**ZA921 Little Court Wratting Road, Haverhill,  
RSA Designers Response  
For CARE (Little Court)  
August 2021**

**Stage 1 Road Safety Audit**

**A143 Haverhill Road, Little Wratting, Suffolk**

**Little Court Care Home Access Arrangements**

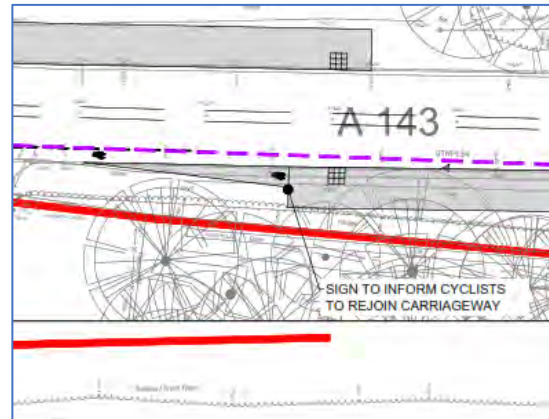
#### 4.1.2. Problem

**Location:** On the A143, eastbound approach to the western pedestrian / cyclist crossing

**Summary:** Reduced forward visibility at the crossing point may lead to pedestrian / cyclist to vehicle collisions

At the crossing, there is reduced forward visibility (stopping sight distance) to the east to / from the northern crossing point. Reduced forward visibility may lead to poor crossing decisions by users and to pedestrian / cyclist to vehicle collisions.

It is recommended that the crossing point is relocated to a point where adequate stopping sight distance is available to the crossing point, consistent with free flow approach speeds.

4.1.2	<p><b>Location:</b> On the A143, eastbound approach to the western pedestrian / cyclist crossing</p> <p><b>Summary:</b> Reduced forward visibility at the crossing point may lead to pedestrian / cyclist to vehicle collisions</p> <p>At the crossing, there is reduced forward visibility (stopping sight distance) to the east to / from the northern crossing point. Reduced forward visibility may lead to poor crossing decisions by users and to pedestrian / cyclist to vehicle collisions.</p>	It is recommended that the crossing point is relocated to a point where adequate stopping sight distance is available to the crossing point, consistent with free flow approach speeds.	<p><b>Noted:</b> This crossing has been removed from the scheme and a crossing point is instead provided just east of the site access.</p>

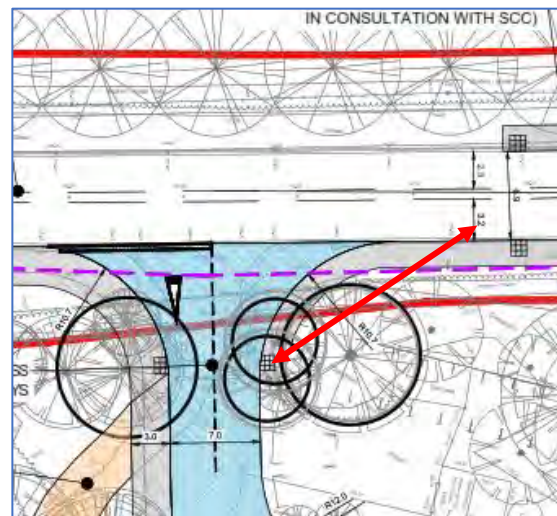
**4.1.3. Problem**

**Location:** On the A143, westbound cycle facility transition from footway to carriageway

**Summary:** Cycle to vehicle collisions at the return to the carriageway

At the transition, cyclists will have difficulty viewing westbound approaching vehicles. The westbound traffic lane is narrowed by the presence of the central hatched markings and a merging cyclist may be vulnerable to collisions with vehicles at this point.

It is recommended that cyclists are encouraged to make the left turn at the development access, making a positive turn on to the A143 rather than a merge manoeuvre (see also Problem 4.1.2 for the recommended relocation of the crossing point).

4.1.3	<p><b>Location:</b> On the A143, westbound cycle facility transition from footway to carriageway</p> <p><b>Summary:</b> Cycle to vehicle collisions at the return to the carriageway</p> <p>At the transition, cyclists will have difficulty viewing westbound approaching vehicles. The westbound traffic lane is narrowed by the presence of the central hatched markings and a merging cyclist may be vulnerable to collisions with vehicles at this point.</p>	It is recommended that cyclists are encouraged to make the left turn at the development access, making a positive turn on to the A143 rather than a merge manoeuvre (see also Problem 4.1.2 for the recommended relocation of the crossing point).	<p><b>Noted:</b> The scheme has been updated to encourage cyclists to cycle on the A143.</p> <p>A crossing point has been provided for eastbound cyclists to access the site.</p>

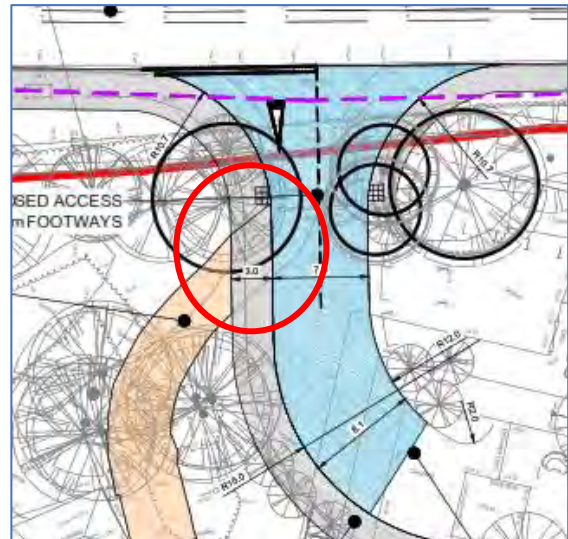
### 4.2.2. Problem

Location: On the A143, eastbound approach to the development access

Summary: High approach speeds may lead to late braking type collisions

The alignment of this section of the A143 is relatively straight and vehicle speeds appeared to be high. Vehicles making a main road right turn may be vulnerable to late braking rear shunt type collisions.

It is recommended that improved advanced warning of the location of the development access is provided. Measures may include but not be limited to providing a flag type sign at the junction, a diagram 506.1 junction warning sign and 'SLOW' carriageway marking to diagram 1024. (There is an existing junction warning sign for the adjacent side road, and this may need to be relocated as part of this recommendation).

4.2.2	<p><b>Location:</b> On the A143, eastbound approach to the development access</p> <p><b>Summary:</b> High approach speeds may lead to late braking type collisions</p> <p>The alignment of this section of the A143 is relatively straight and vehicle speeds appeared to be high. Vehicles making a main road right turn may be vulnerable to late braking rear shunt type collisions.</p>	It is recommended that improved advanced warning of the location of the development access is provided. Measures may include but not be limited to providing a flag type sign at the junction, a diagram 506.1 junction warning sign and 'SLOW' carriageway marking to diagram 1024. (There is an existing junction warning sign for the adjacent side road, and this may need to be relocated as part of this recommendation).	<b>Noted:</b> Additional signing and road markings will be provided. See Drawing ZA921-PL-SK-001-P09.

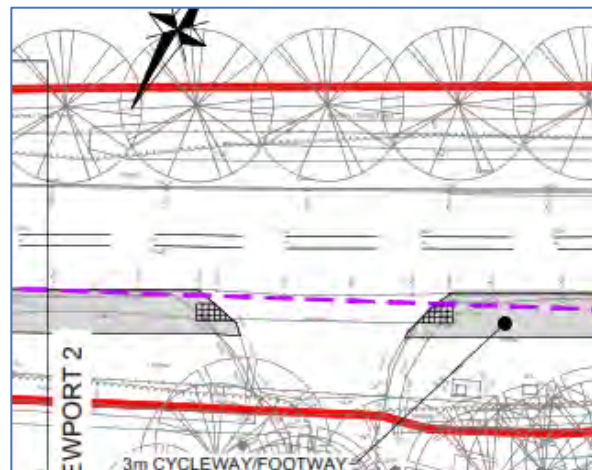
Location: Driveway off A143

The driveway is shown as a fully kerbed access. It would appear to be a single property access and it may be appropriate to provide this as a dropped kerb crossover, to remove the need for tactile paving.

5.2	<p><b>Location:</b> Driveway off A143</p> <p>The driveway is shown as a fully kerbed access. It would appear to be a single property access and it may be appropriate to provide this as a dropped kerb crossover, to remove the need for tactile paving.</p>		<b>Noted:</b> The updated scheme removes the need to cross this side road.

DRAWING NUMBER	REV.
ZA921 - PL - SK - 006	P02

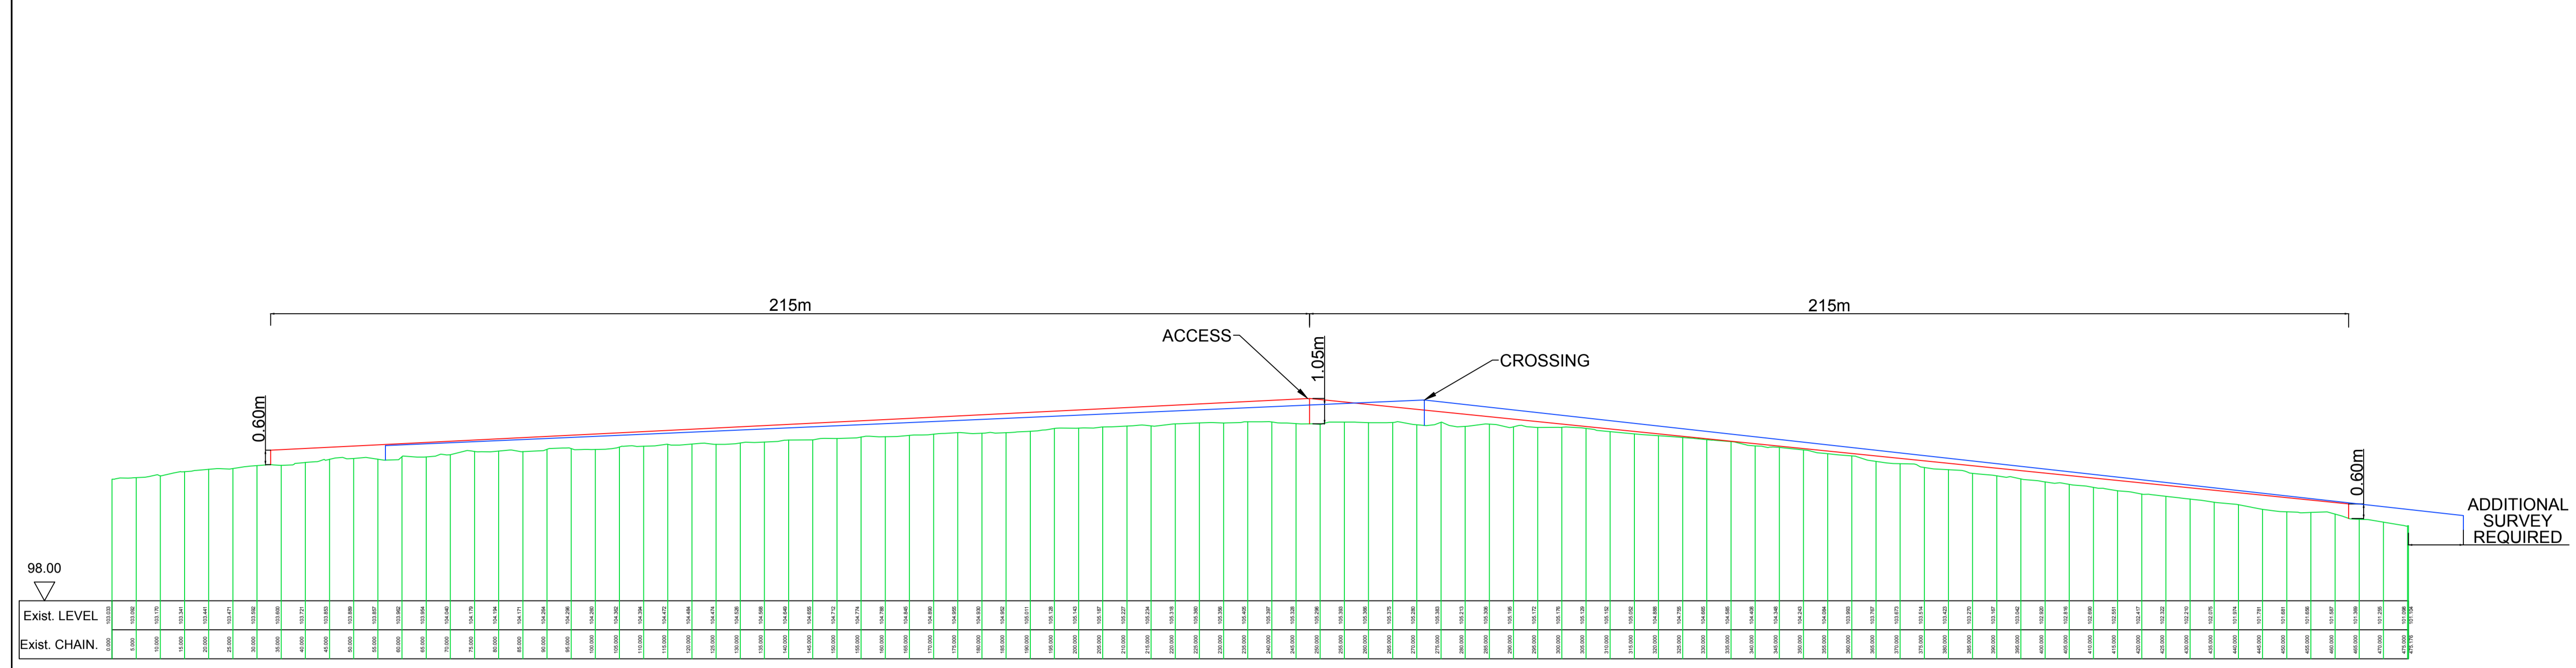
4.1.1	<p><b>Location:</b> At the eastern crossing point for bus stop</p> <p><b>Summary:</b> Reduced forward visibility at the crossing point and high approach speeds may lead to pedestrian to vehicle collisions</p> <p>The A143, east of the development access, has a slight rolling vertical crest curve, with a raised verge area along the southern side of the A143. This may reduce the forward visibility (stopping sight distance) to and for pedestrians crossing at the bus stop hardstanding. Reduced forward visibility may lead to pedestrian to vehicle collisions, particularly as this section of the A143 is on a straight alignment and vehicle speeds appeared to be high.</p>	It is recommended that adequate forward visibility (stopping sight distance) is provided at the crossing point, consistent with free flow approach speeds.	<p><b>Drawing ZA921-PL-SK-006-P02</b> has been prepared to demonstrate that vertical visibility is achievable to the site access and proposed crossing points.</p> <p><b>Drawing ZA921-PL-SK-001-P09</b> shows the updated site access strategy.</p>

<b>4.2 Junctions</b>				
4.2.1	<p><b>Location:</b> At the development access</p> <p><b>Summary:</b> Reduced side road visibility and high approach speeds may lead to failure to give way type collisions</p> <p>The A143, east of the development access, has a slight rolling vertical crest curve, with a raised verge area along the southern side of the A143. This may reduce the side road visibility to the right from the</p>	It is recommended that adequate side road visibility is provided, consistent with free flow approach speeds.	<p><b>Drawing ZA921-PL-SK-006-P02</b> has been prepared to demonstrate that vertical visibility is achievable to the site access and proposed crossing points.</p> <p><b>Drawing ZA921-PL-SK-001-P09</b> shows the updated site access strategy.</p>

P02	CROSSING REMOVED	-	DP	-	08/2021
P01	PROPOSED CROSSING VISIBILITY SPLAYS ADDED	-	DP	-	05/2021
REV	DESCRIPTION	DE	DR	CH	DATE
DESIGNED BY	DRAWN BY	CHECKED BY			
-	DP	-			
SCALE @ A1 SIZE		DATE			
D.N.S.		29/07/2021			
PROJECT TITLE					
LITTLE COURT, WRATTING ROAD, HAVERHILL					
DRAWING TITLE					
VISIBILITY PLAN					
CLIENT					
CARE (LITTLE COURT) LTD
